# Iris Fabrics Ltd. (9447)

24.MARCH.2014

ACCORD  
on Fire and Building Safety in Bangladesh

# Site Observations

## High Levels of Storage

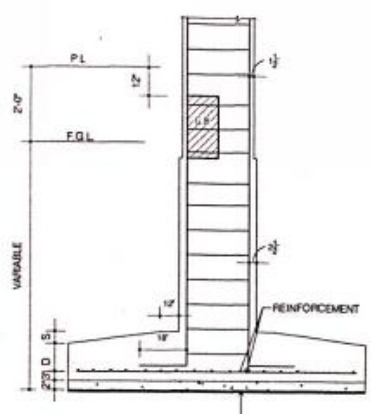
**ITEM 1: (Priority 1) Slab loadings were quite high throughout Building A in localized areas due to high storage loads. The dormitory is being used for excessively high levels of storage during its construction.**

Storage levels were higher than desirable in localized areas distributed throughout Building A.

Storage levels were very high and widely distributed throughout the Dormitory.

- Reduce storage loads throughout factory Building A and throughout Dormitory to design load levels

- Factory engineer to develop and actively monitor a loading plan for all floor plates within the factory complex giving consideration to slab, column and foundation capacity.

Foundation Overloading

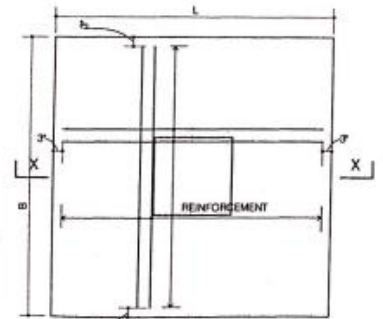
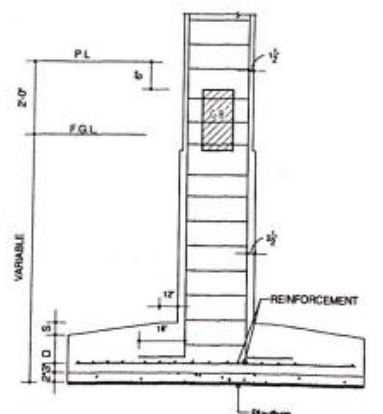
**ITEM 2: (Priority 2) Soil bearing capacity does not appear adequate to safely support the loads developed at the footing level of Building A.**

Soil bearing capacity does not appear adequate to support spread footing loads

- Detailed engineering assessment to be performed upon Building A foundations

- Implement all works mandated by the above mentioned detailed engineering assessment
